City of Cambridge

CALENDAR ITEM # 1

ORDERED: That the Commissioner of Public Works be authorized to construct curb cuts over sidewalks in front of estates upon the streets as hereinafter named, the expense thereof to be charged to the appropriation for Public Works Department, Paving (Edgestones and Sidewalks). The entire cost of material and labor furnished to be repaid to the City by the owners of abutting estates.

SUBJECT: Curb Cut at 20 Shepard Street, Cambridge, MA.

DRIVEWAY PAVING for
20 SHEPARD STREET
CAMBRIDGE, MA

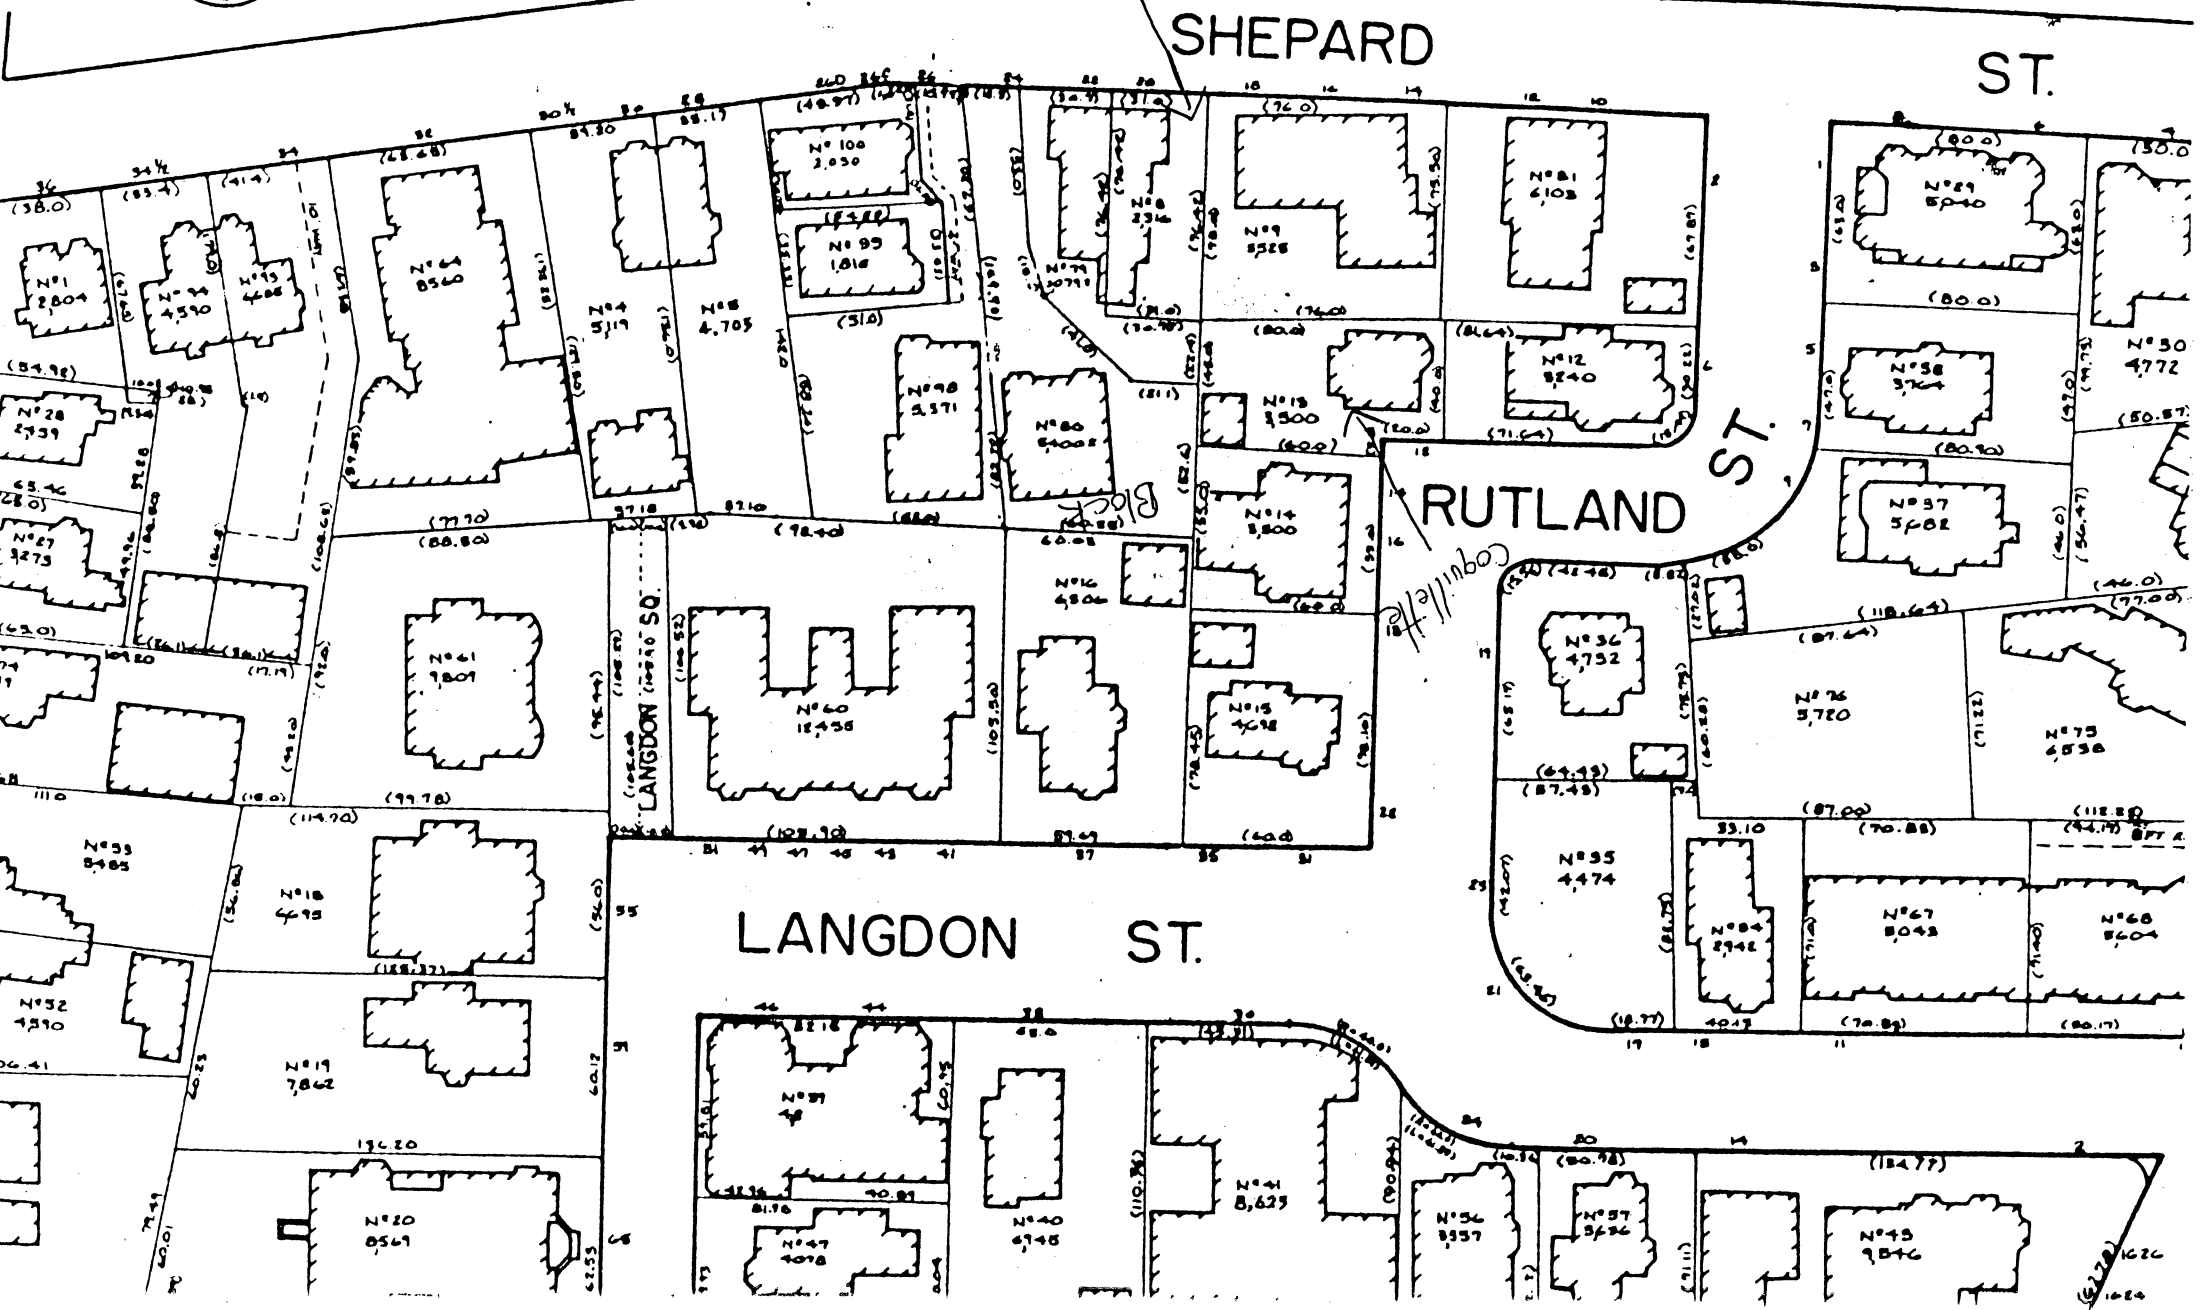
- C) Section 6.44b does not allow parking without a 5'0 buffer at side lot line.
 - D) Section 6.477 does not allow parking to impinge on front yard public space. (The proposed parking strip effectively extends the street into the private residential space with no proper buffer or separation--a row of brick etc. would not provide an effective separation.)

- E) Section 6.471 does not allow parking without screening. The section is very specific. The proposed 7" between edge of parking and lot line, for example, does not provide the 5'0" requirement for densely planted buffer.

- F) The parking would extend into the current front yard setback (of minimum 10' at pre-existing building)
2. The parking would be an exterior change to a non-conforming building per zoning section 5.30. The present building does not meet current standards regarding:

Ms. Shanel has made every effort to provide an aesthetically pleasing driveway by retaining a landscape architect and using bricks rather than asphalt. The driveway will extend approximately 30 feet into the property and will not be visible to either the Coquilletes or the Blocks. I am enclosing a site plan of the area depicting the location of the proposed driveway and its relationship to these two property owners.

NOTES:
RECOMMENDED DRIVEWAY TREE
CARPINUS BETULUS 'COLUMNARIS' or
'FASTIGIATA'
ROOT BALL MAY EXCEED 15'
